Technical Service Bulletin: TSB180083

V-Ribbed Belt Tension Drive Load Change for Industrial Applications

Figure 1, Location of Additional Washer

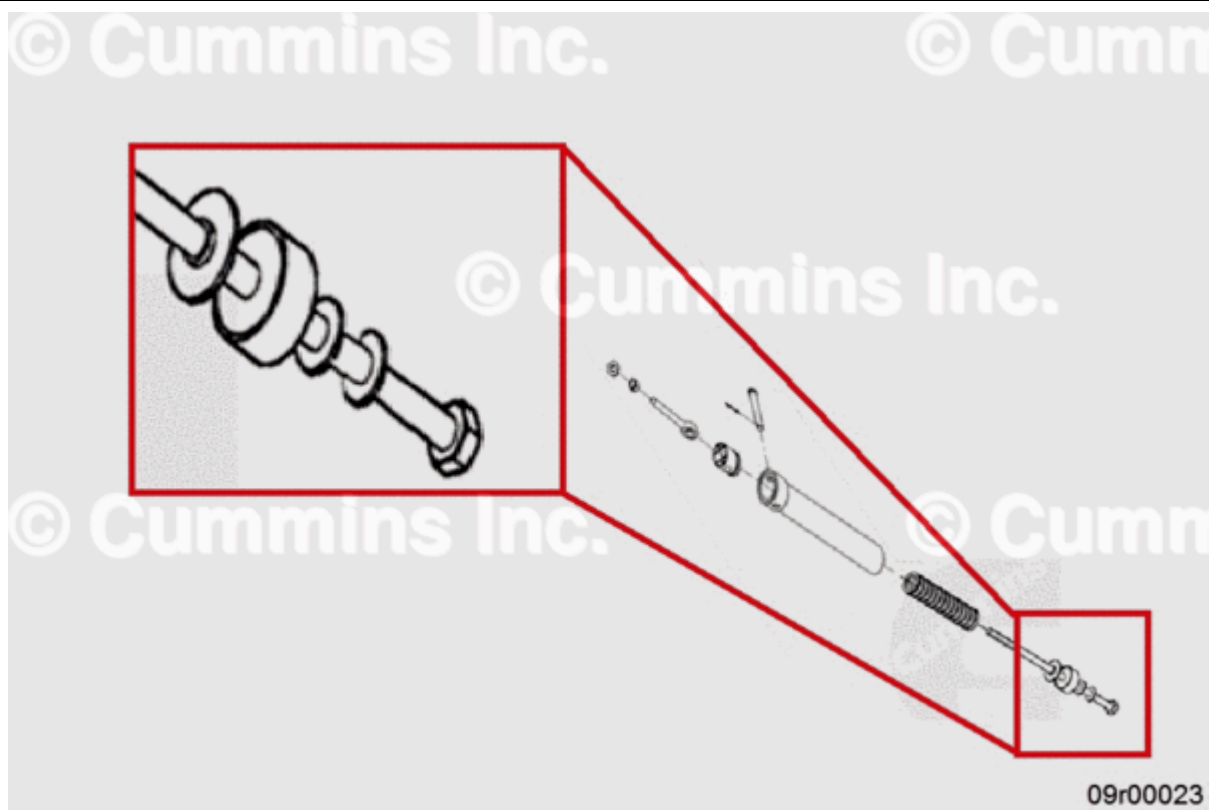
- High coolant temperature fault code caused by belt rib wear, belt pattern wear, or belt shredding.

- High inertia fan blade and high deacceleration rate spikes can lead to belt wear or malfunction.

After verifying belt tension is below 525 or above 625 lbs, adjust belt tension using belt tension gauge tool, Part Number 3164750. Reference procedure 008-087 in the corresponding Service Manual. If tension load adjustment does **not** reach 525 lbs, and belt does **not** align properly, add additional washer, Part Number 3036900, to tensioner assembly as shown in Figure 1 below.
